SERVICE MANUAL

Oberheim

OB-8

First Edition
January 1983

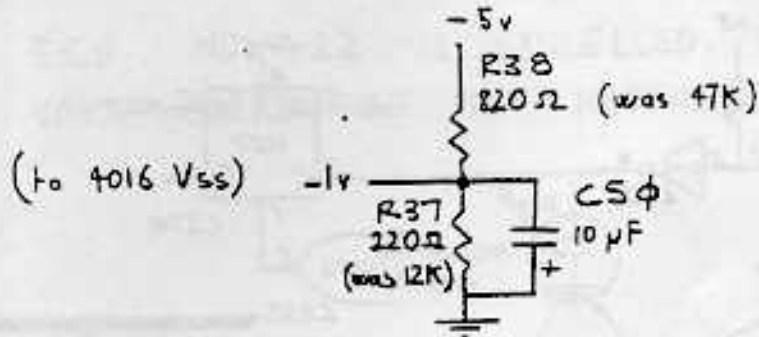
- change value of -1 divider on each voice board

08-8 MOD CAN SCHEMATIC
SHEET 1 OF 1.

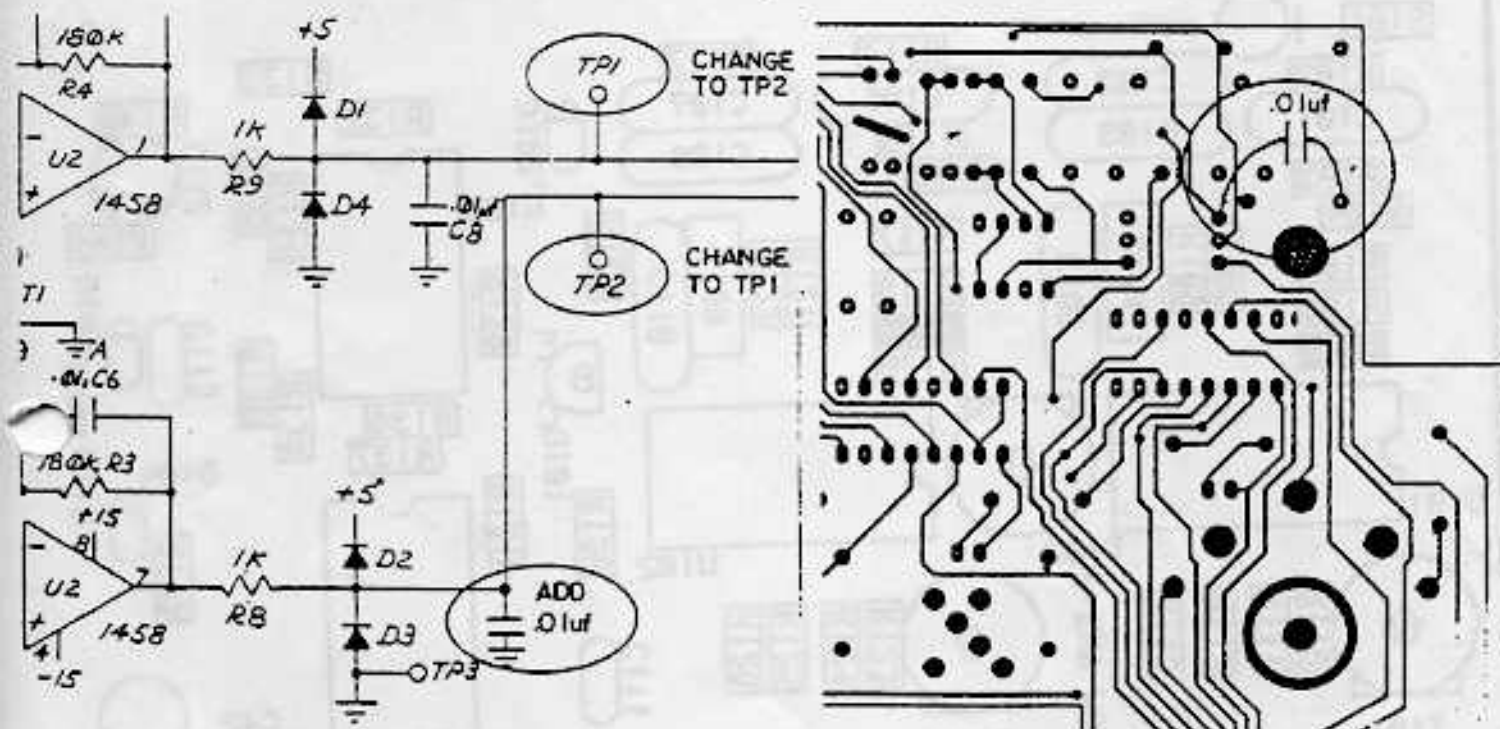
REMOVE NOISE MODULATION FROM
VIBRATO LEVER, AND CORRECT
SCHEMATIC.

1. CHANGE SCHEMATIC AS SHOWN.
2. ADD .01uf CAP (08.153004) FROM GROUND TO TEST POINT (T.P. 2) OF MOD CAN PCB ON 1666 SIDE OF BOARD.

DRAWINGS AFFECTED VOICE BOARD
SCHEMATIC 1682B SHEET 3 OF 3

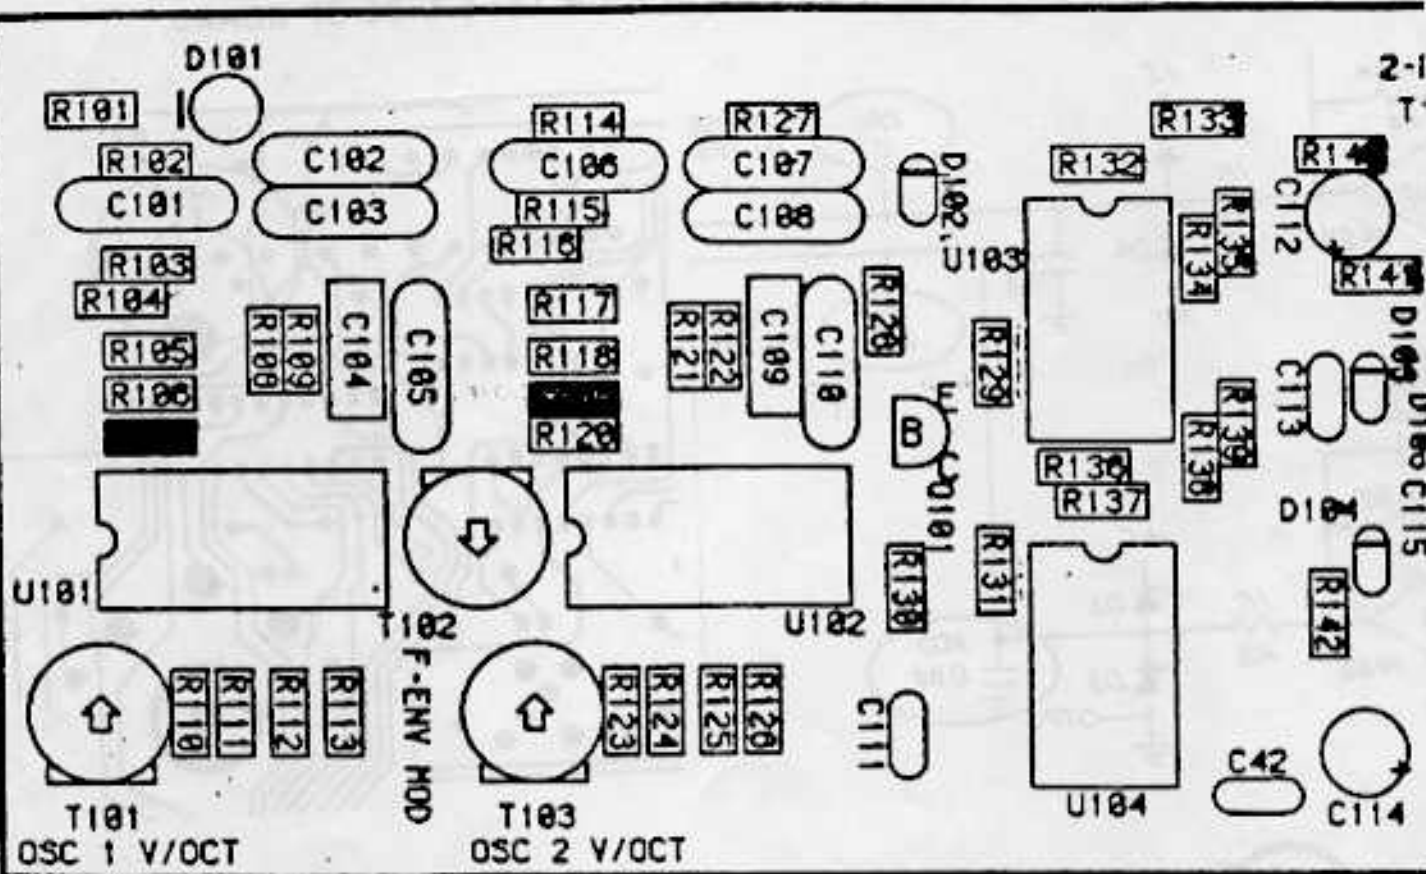
LOWER INITIAL FREQUENCY OF 3340
TO ACCOMMODATE A WIDER RANGE
OF CHARACTERISTIC VARIATIONS ON
THE 3340.

REPLACE RESISTOR RX07 AND RX19 (215K, 1%)
WITH 174K, 1% (OB#475520).
